Grimes Planning & Zoning Commission Meeting February 6, 2024 In Person at Grimes Community Complex, 410 SE Main Street, Room 202

Tru Hotel Site Plan

RE: Tru Hotel Site Plan

The Development Services Department is in receipt of a proposed Site Plan for the Tru Hotel. Based on the review of the provided submittal materials, staff have the following comments:

C1.1

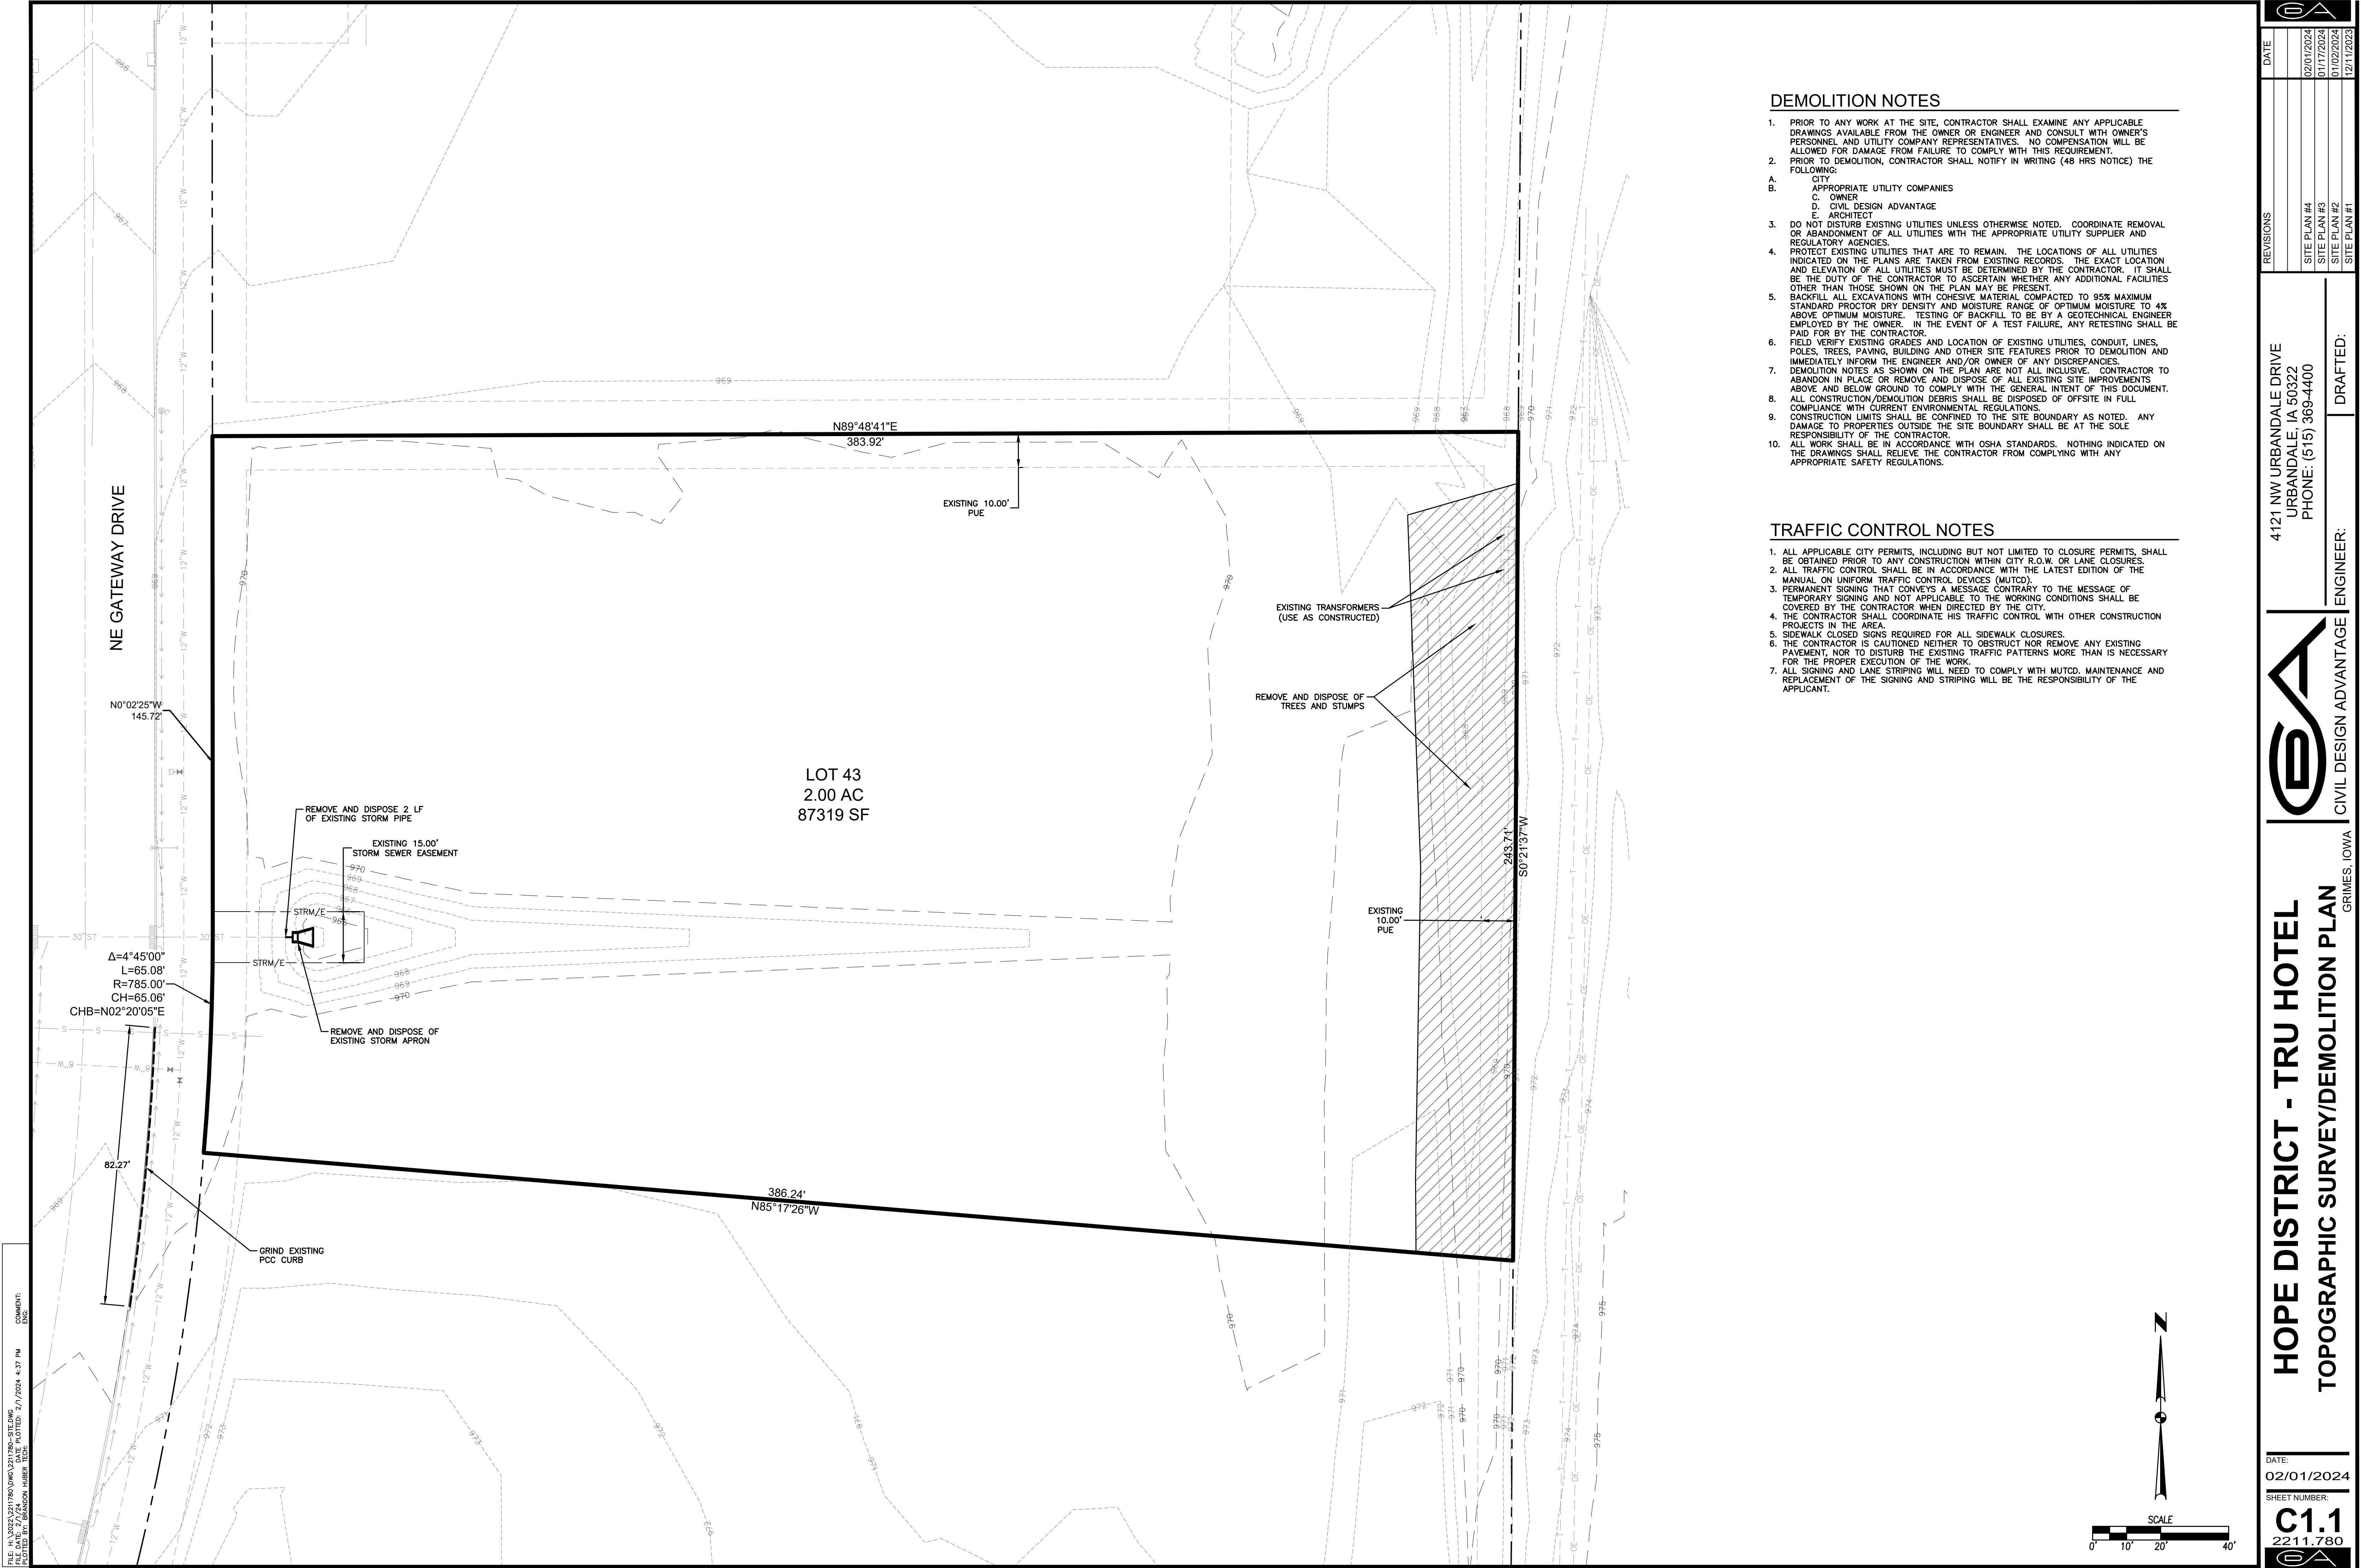
- ~~1. Show valve for the 8 inch service to the west.~~

DATE: 02/01/2024
SHEET NUMBER: **C3.1**
2211.780

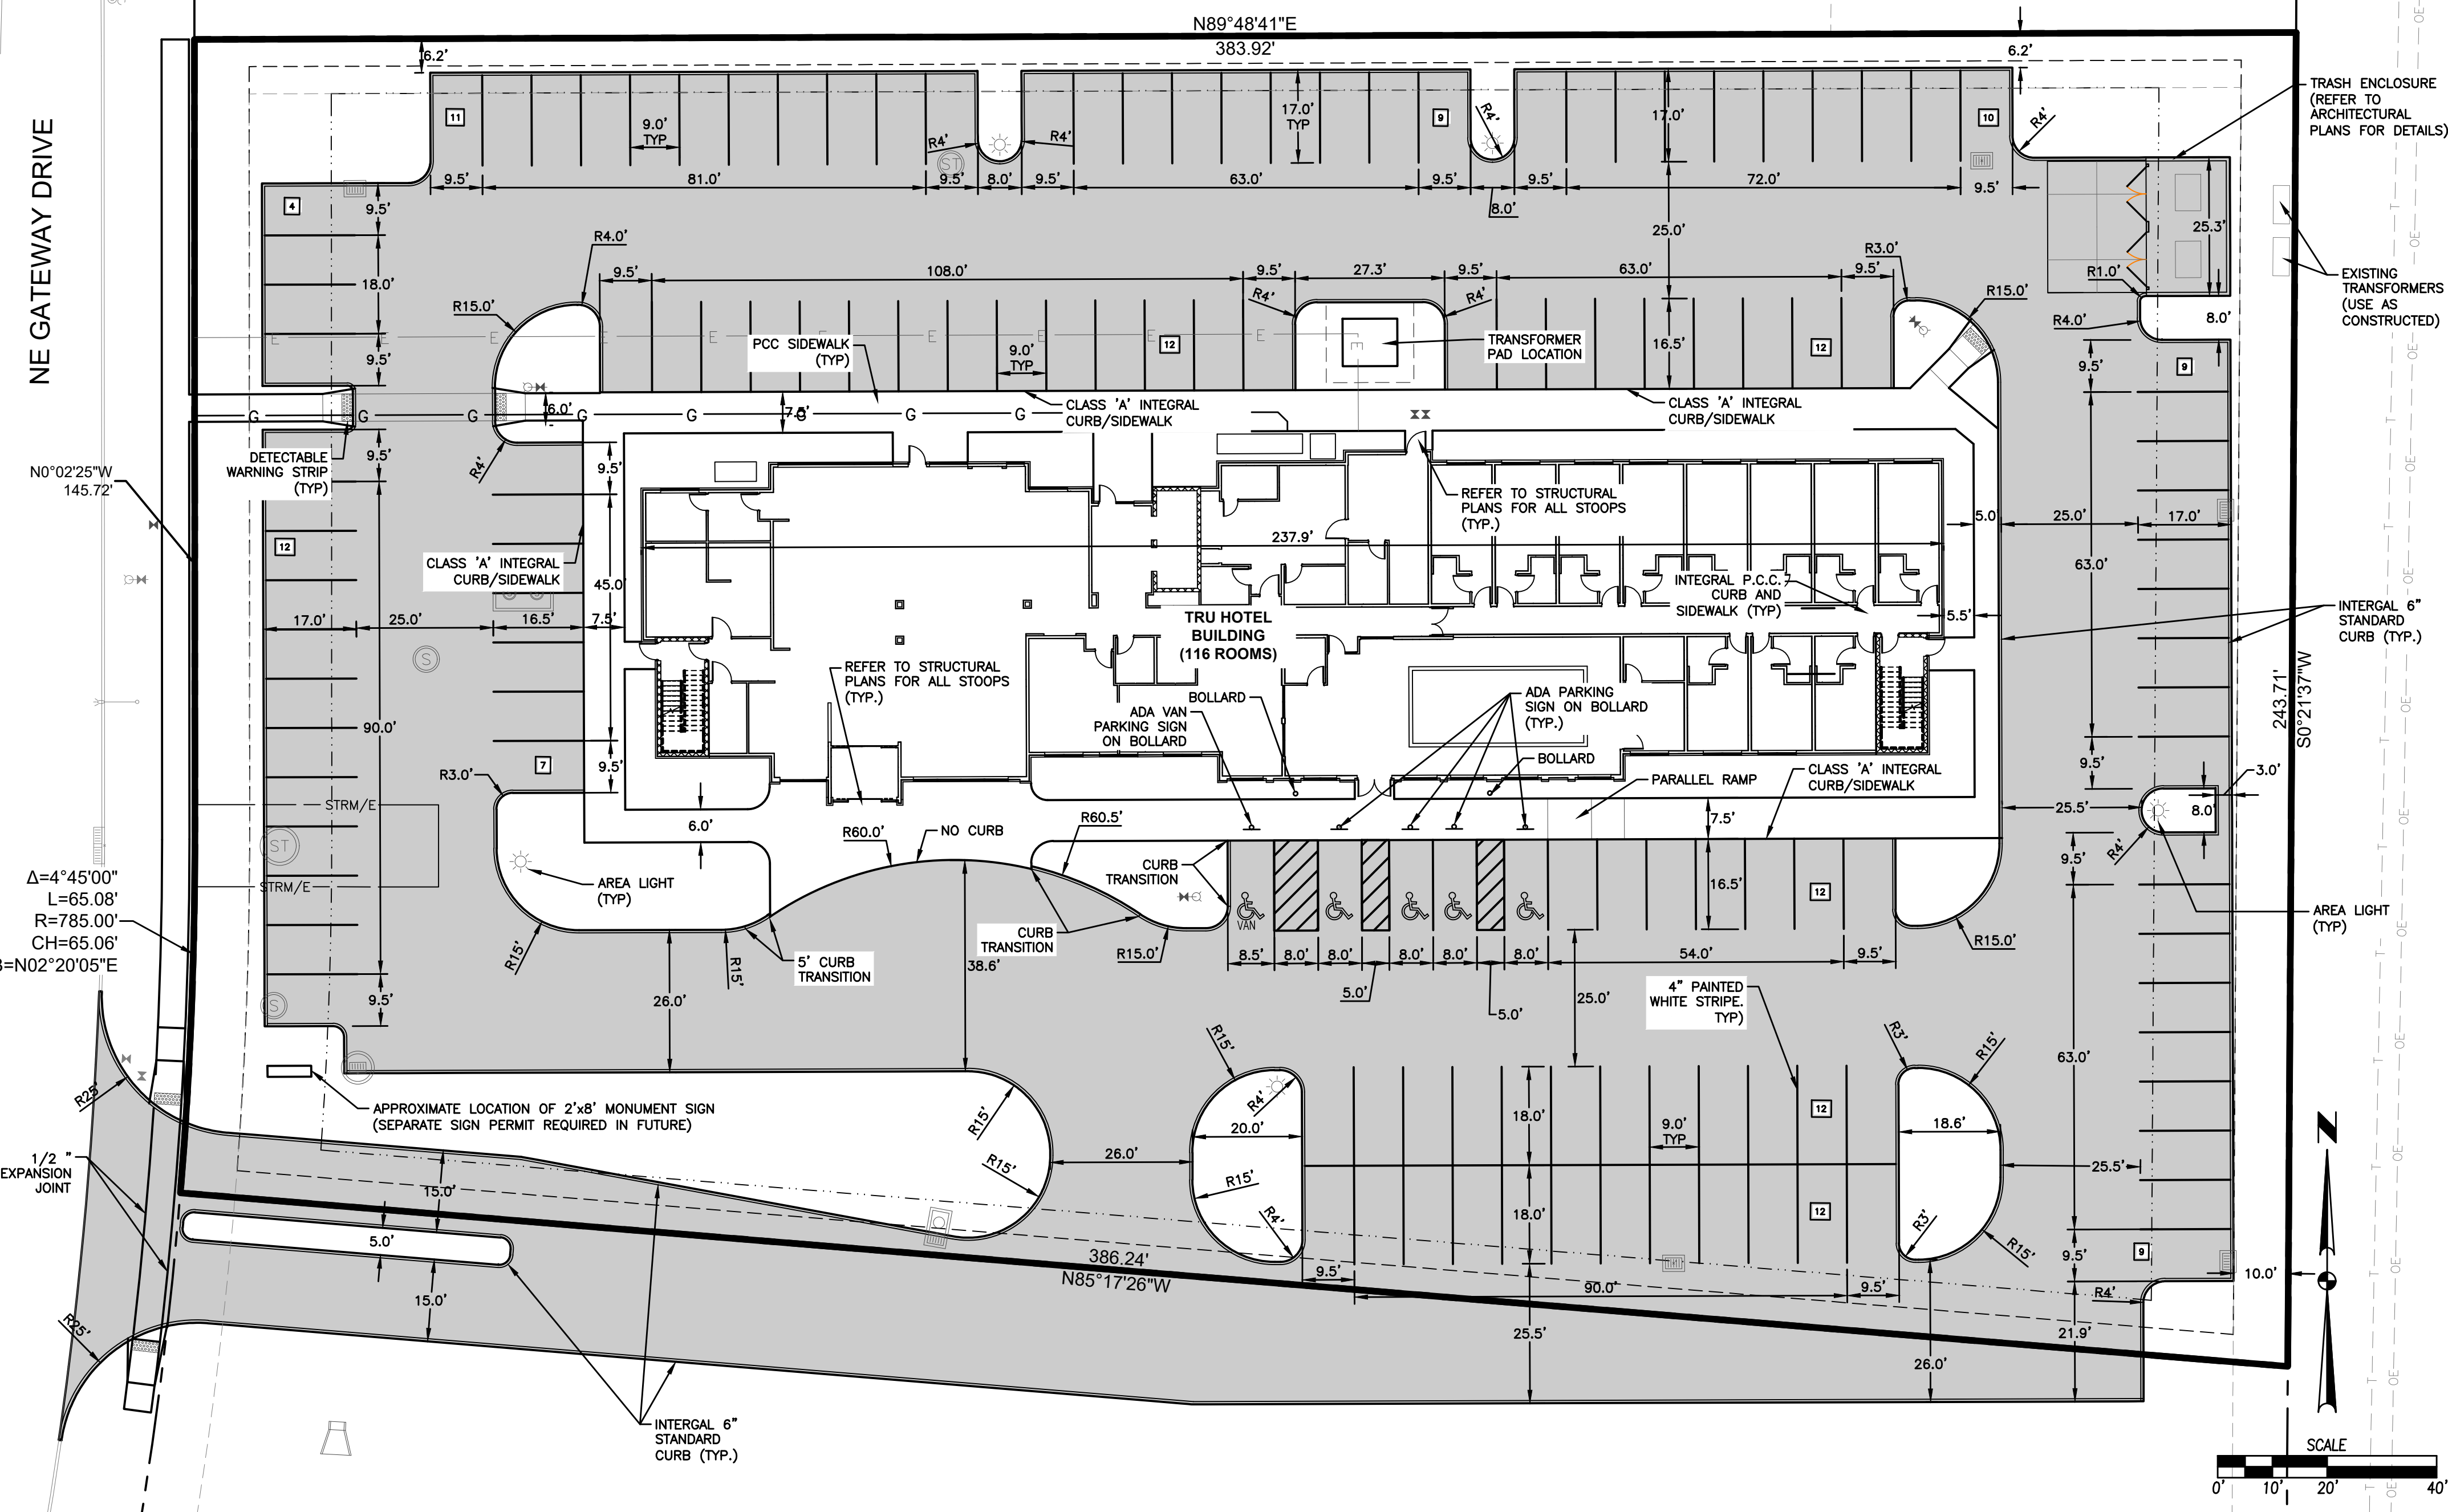
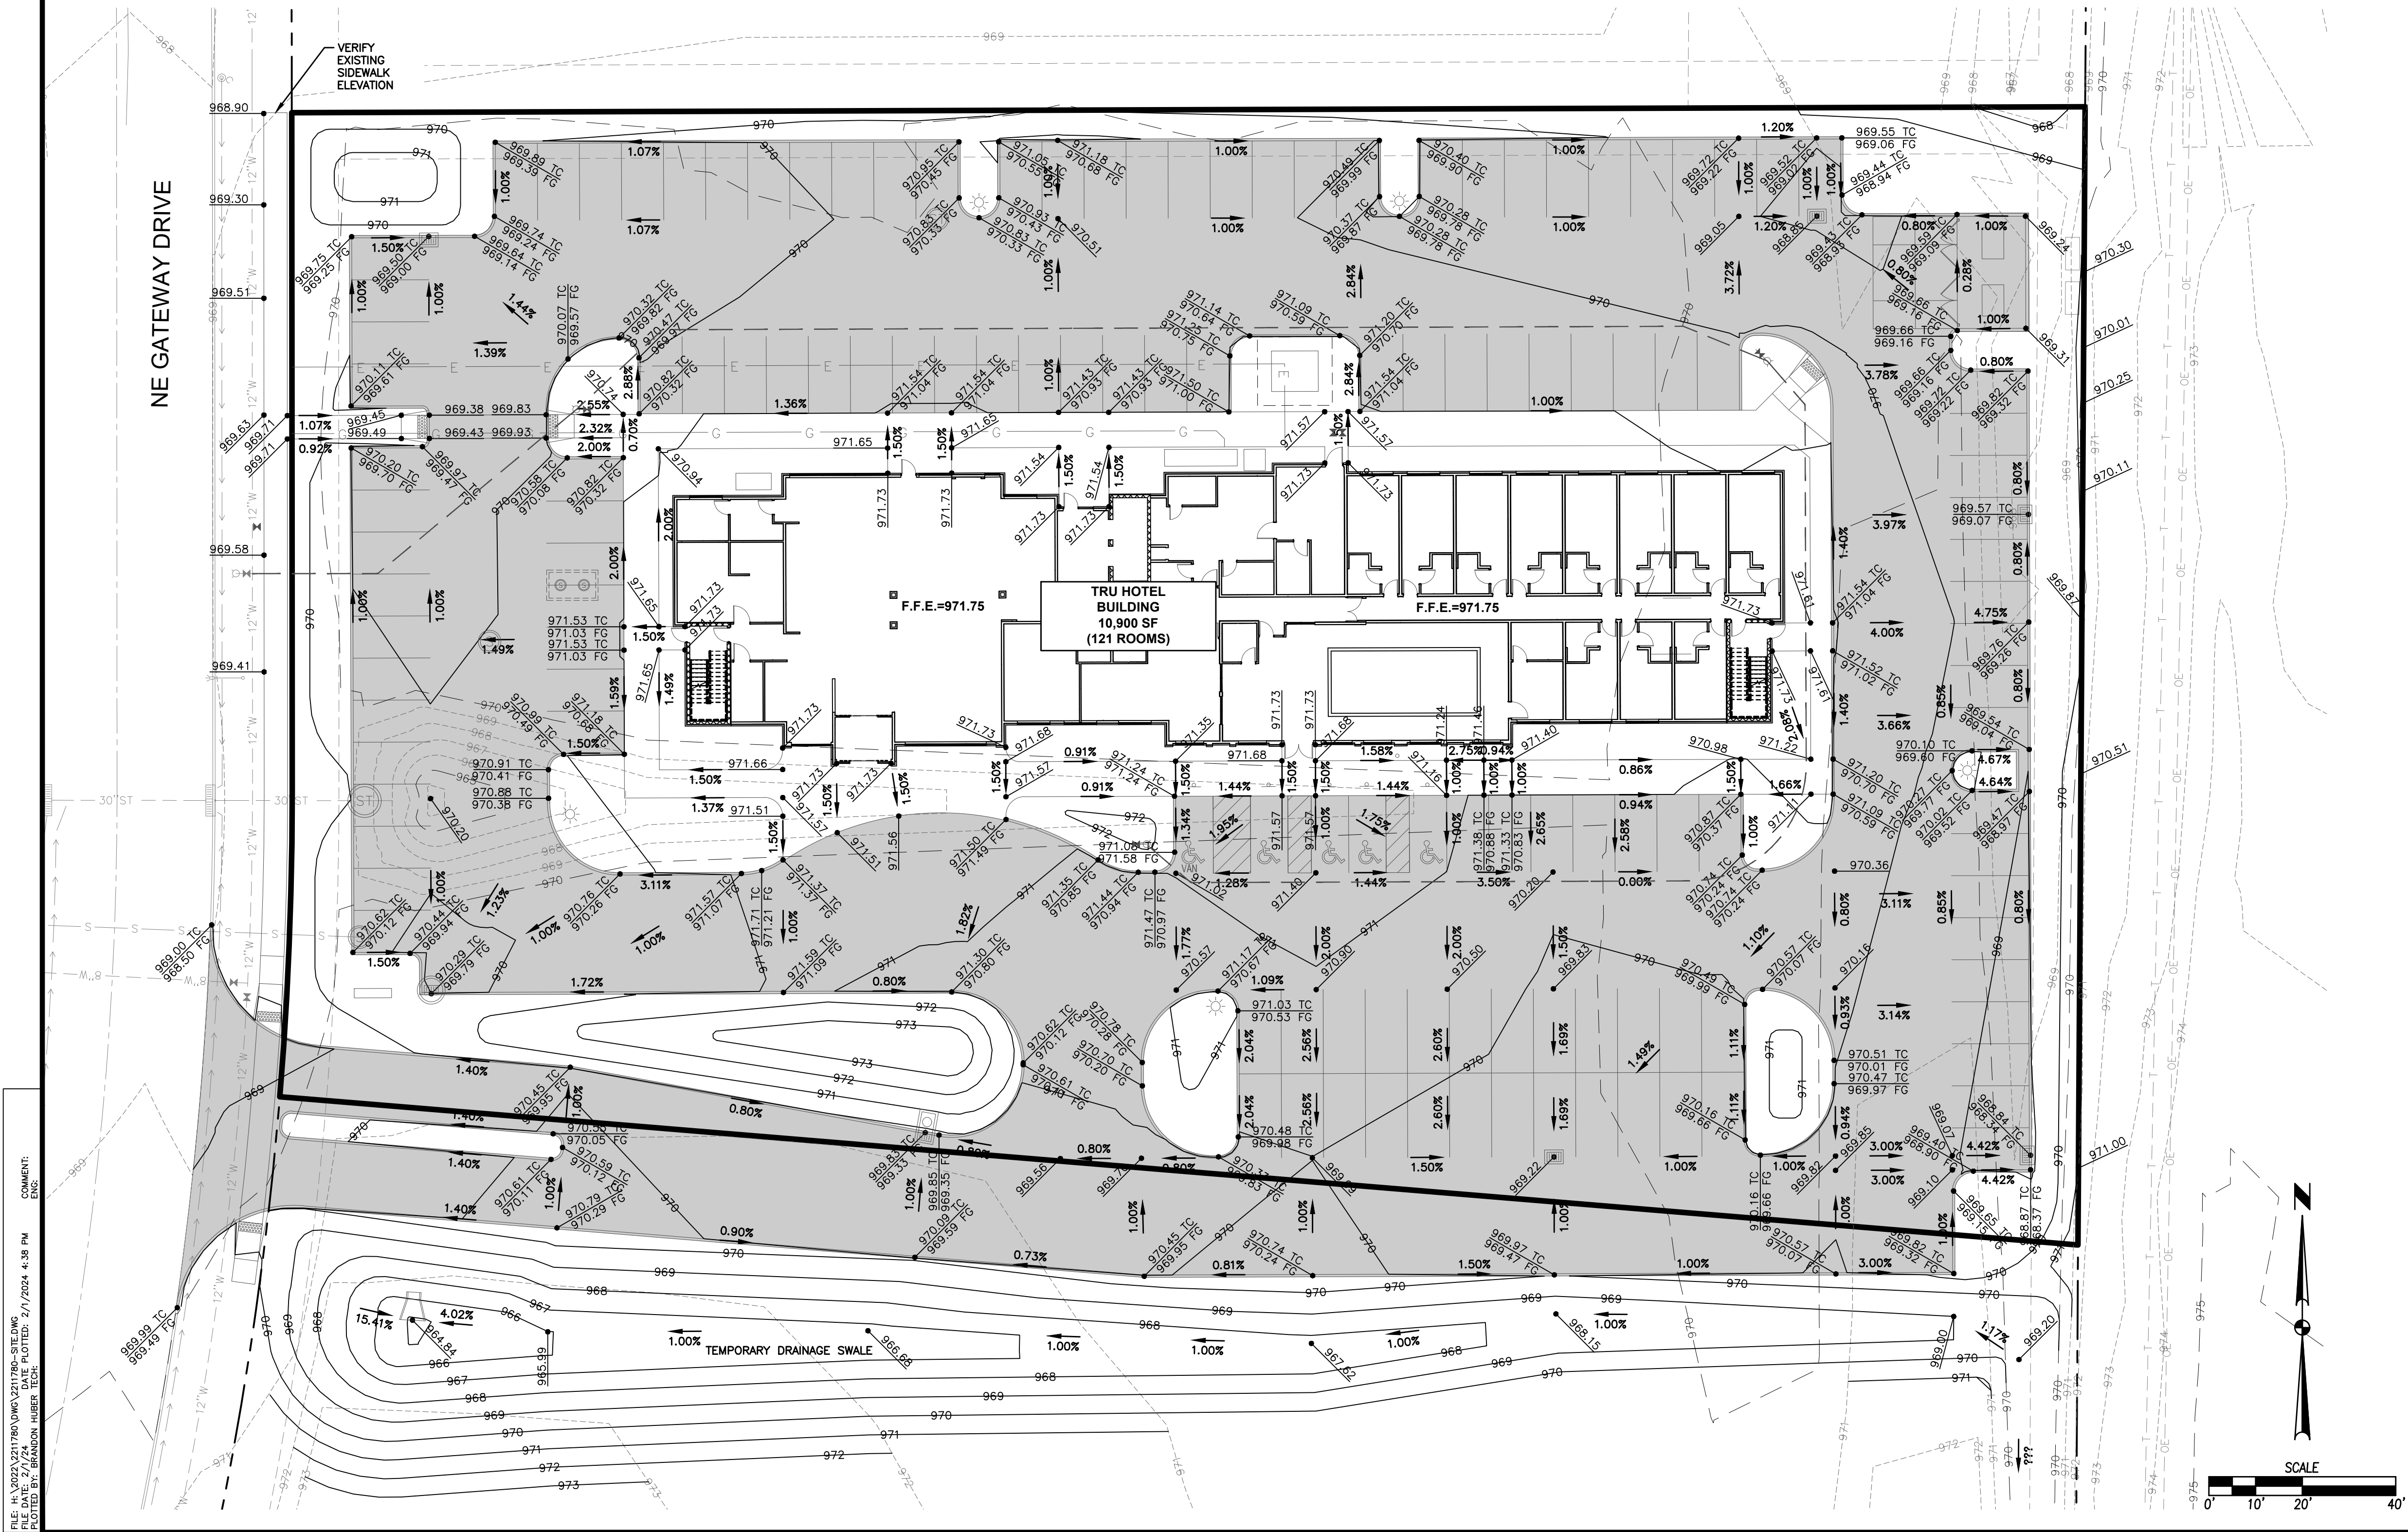
- ~~1. Verify tie in elevation for the public sidewalk to the north.~~
- ~~2. Staff would suggest moving some ADA parking to the north side of the building.~~
